# Corporate Report

**SUBJECT:** **Report on Comments – Draft Port Credit Local Area Plan And  
Built Form Guide - Ward 1**

**Response To Comments Table – Draft Port Credit Local Area Plan**

### Summary of Proposed Redesignations and Modifications to Schedule 10 Land Use Designations (Mississauga Official Plan)

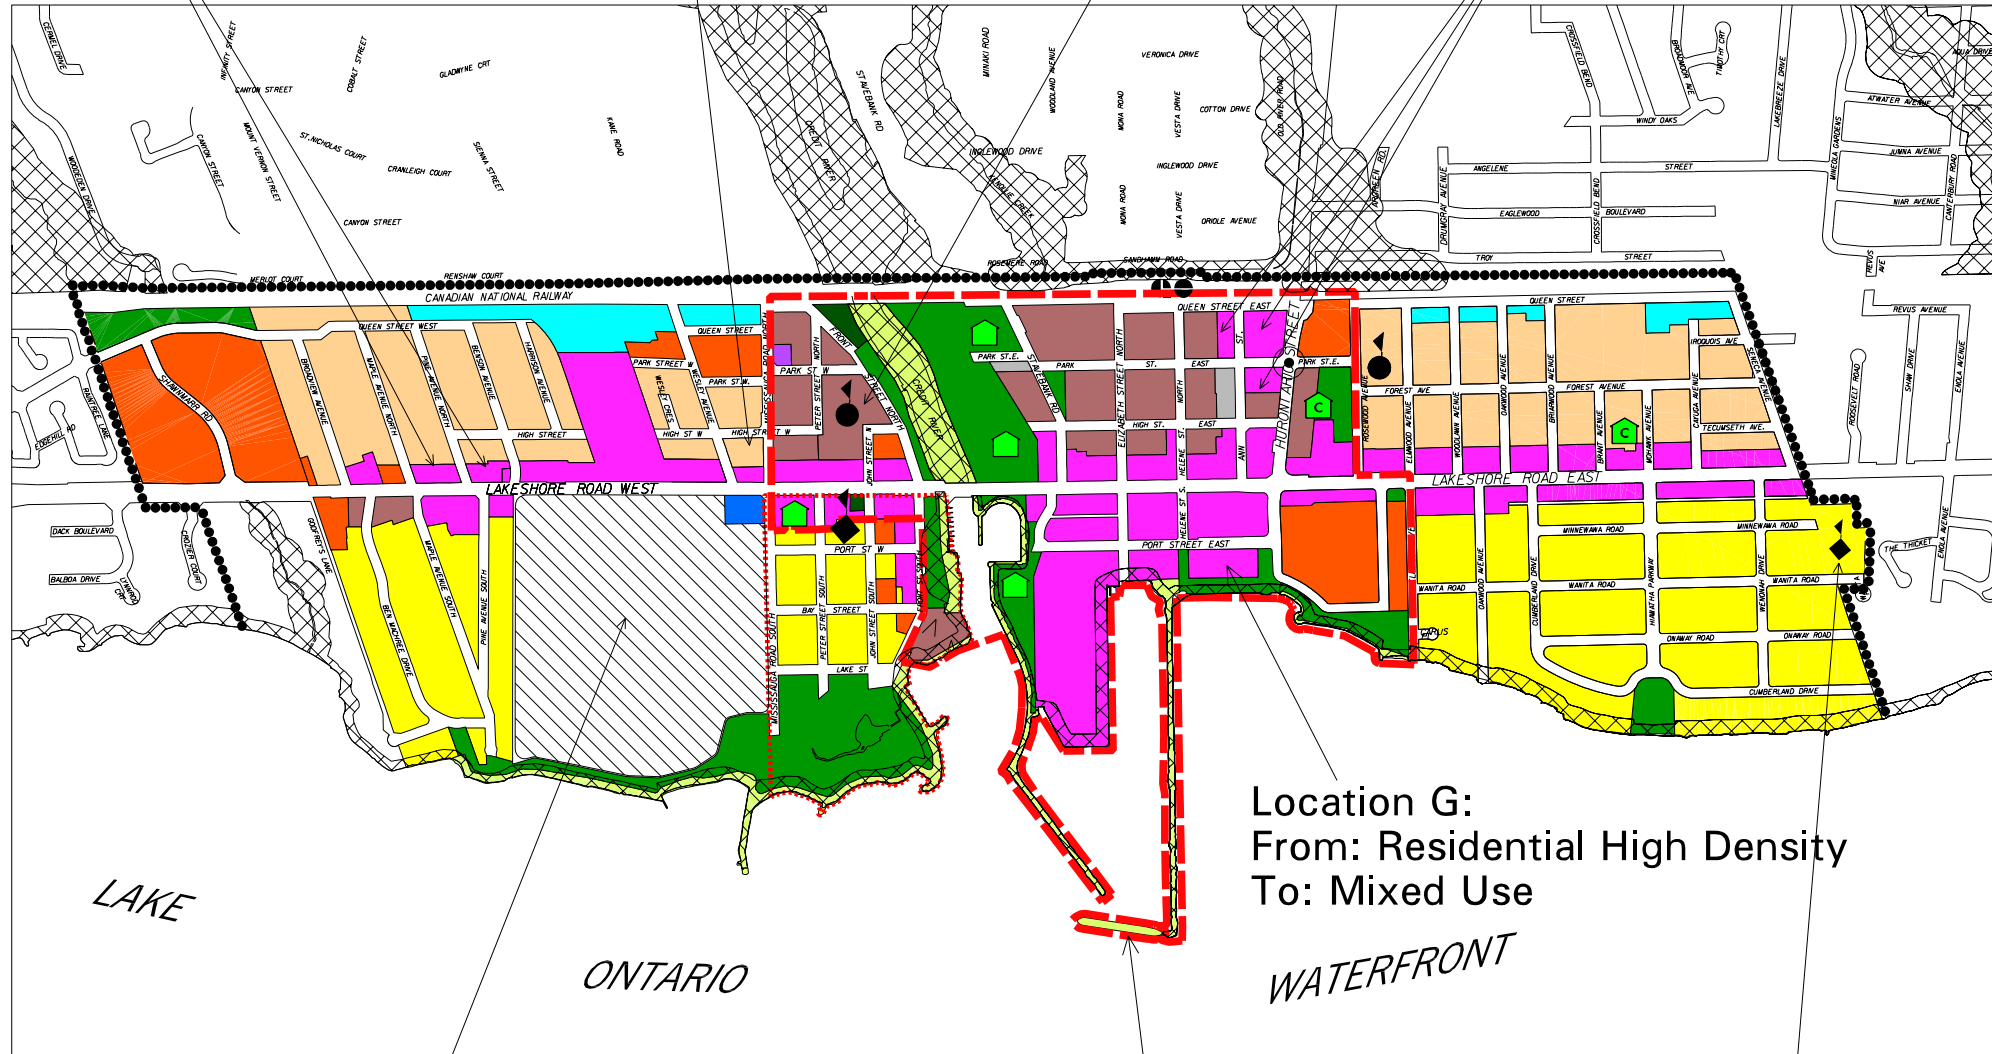
Attached as Appendix 1 is a summary of the key issues and comments raised through the circulation and public consultation process and proposed changes, where appropriate. Appendix 2 identifies proposed changes to land use designations in Port Credit<sup>1</sup>.

Location D:  
From: Residential Medium Density  
To: Residential High Density

Location C:  
From: Residential High Density  
To: Residential Low Density II

Location E:  
From: Residential High Density  
To: Mixed Use

# Potential Opportunities for Road Network Improvements and Higher Order Transit

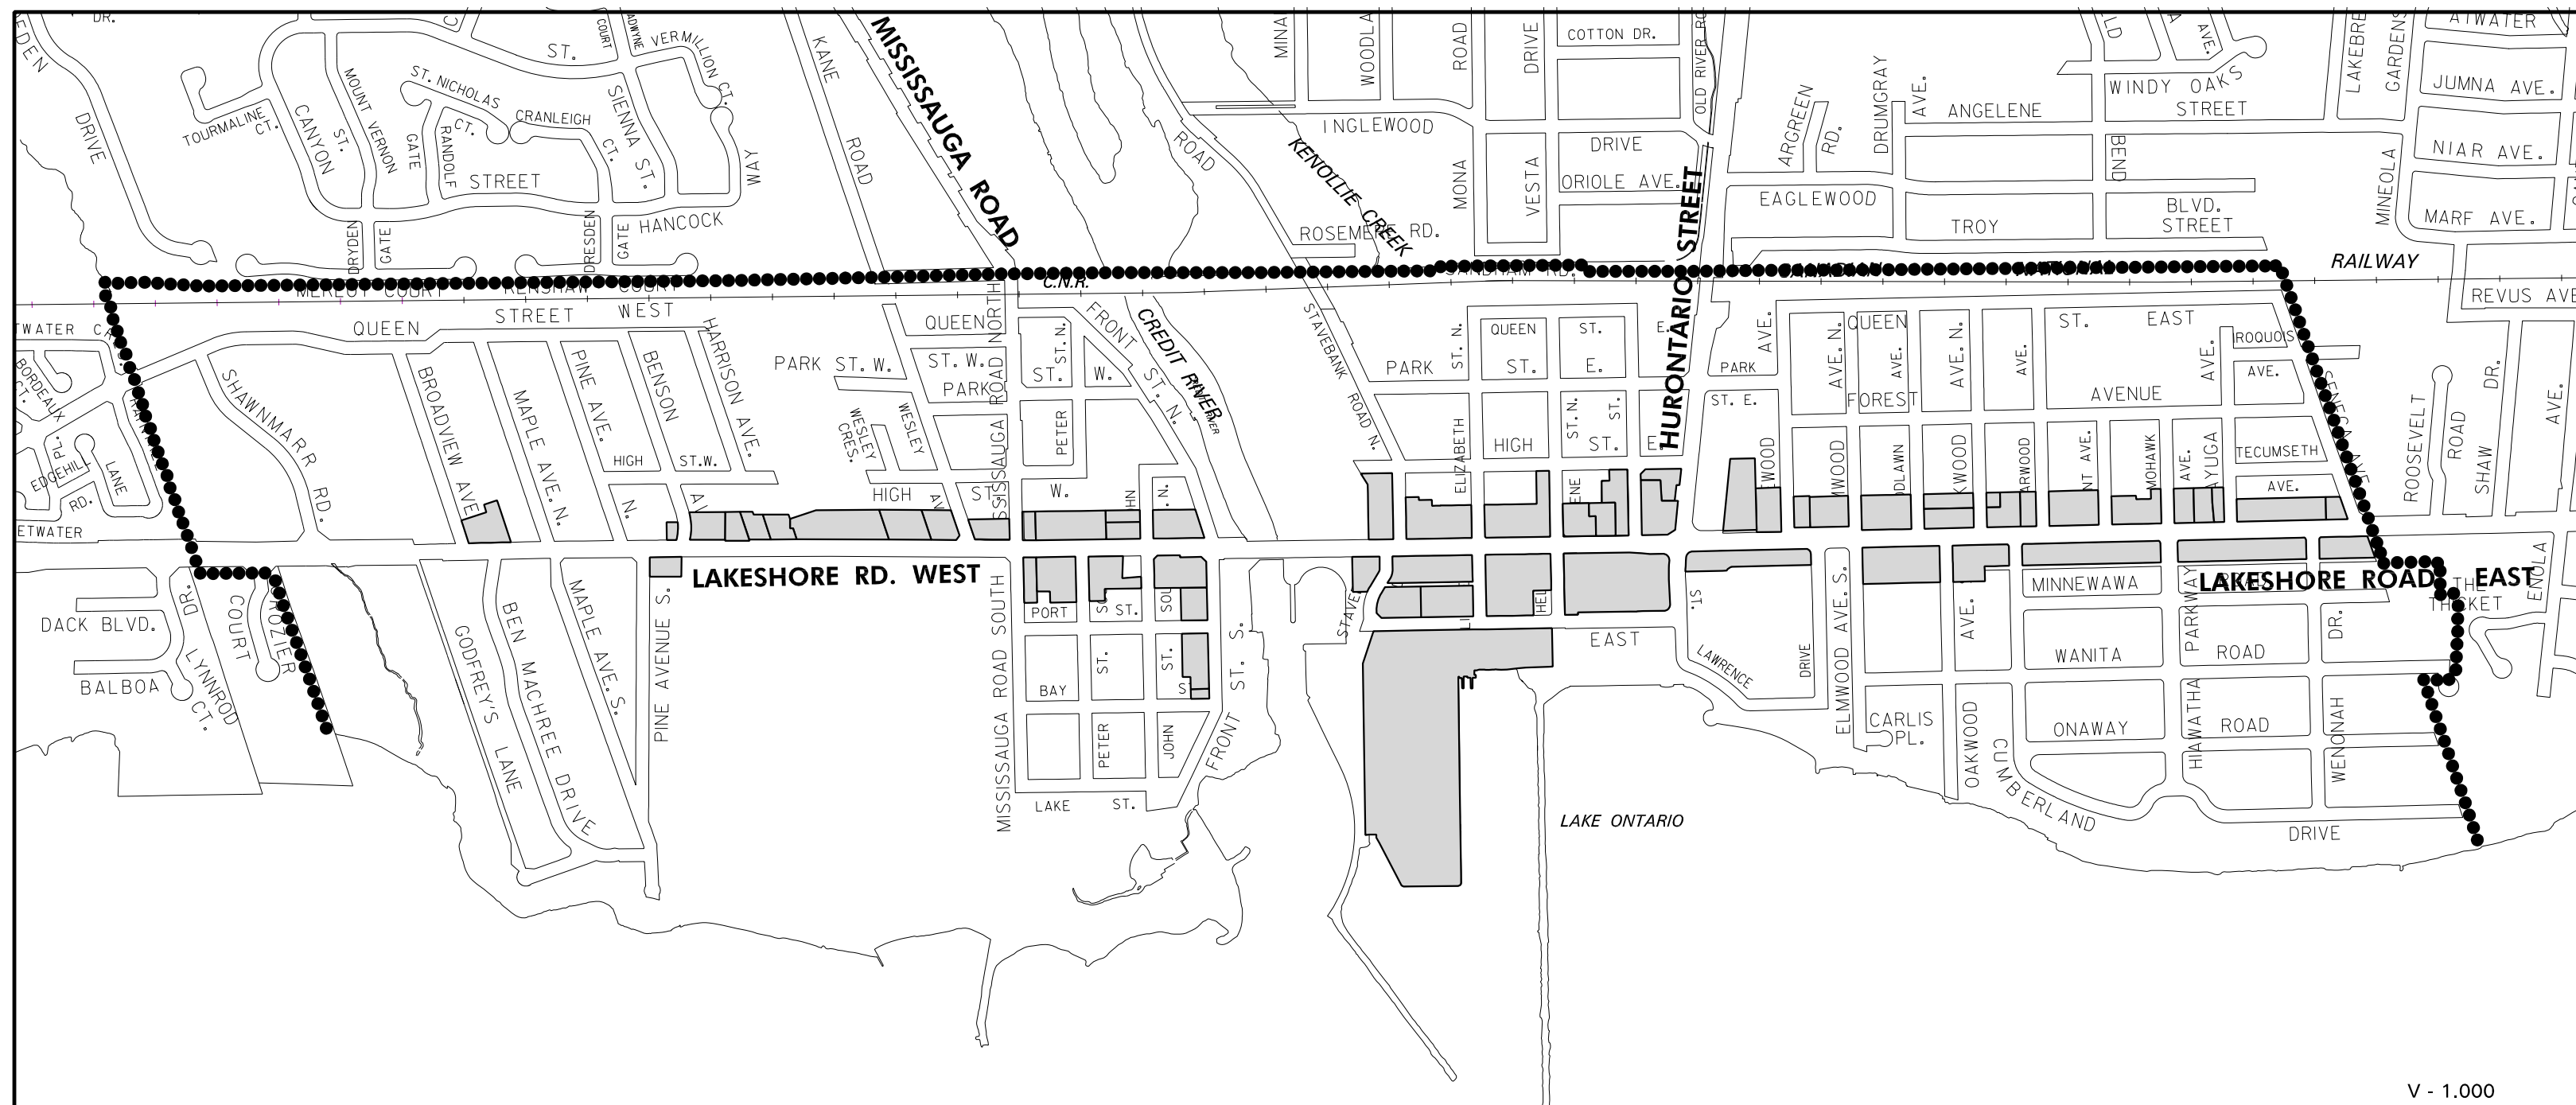
- identifying opportunities for road connections that promote a fine grain road network. Potential road connections would be evaluated should an application to redevelop a property be submitted or through a Transportation Master Plan. A figure will be added to the Area Plan to illustrate these opportunities (see Appendix 6);

Transportation	9.1.13 Multi-Modal	Local Area Plan	Agreed.	26 That a new figure be added that

Respondent	Section	Issue	Comments	Recommendation To Draft Port Credit Local Area Plan
and Works	Network	should conceptually illustrate potential road and transit network improvements.		illustrates potential opportunities for road network improvements and higher order transit.
Transportation and Works	9.1.14 Multi-Modal Network	Local Area Plan should clarify that transportation and traffic studies are required for new development in Port Credit and that these studies have to identify strategies for limiting impacts.	Agreed.	27 That a new policy 9.1.14 be added to read: <i><u>Development applications will be accompanied by transportation and traffic studies. Studies will address, amongst other matters, strategies for limiting impacts on the transportation network, where appropriate, including measures such as:</u></i> <ul style="list-style-type: none"> <li>- <i><u>reduced parking standards;</u></i></li> <li>- <i><u>transportation demand management;</u></i></li> <li>- <i><u>transit-oriented design of the development;</u></i></li> <li>- <i><u>pedestrian/cycling connections; and</u></i></li> <li>- <i><u>access management plan.</u></i></li> </ul>
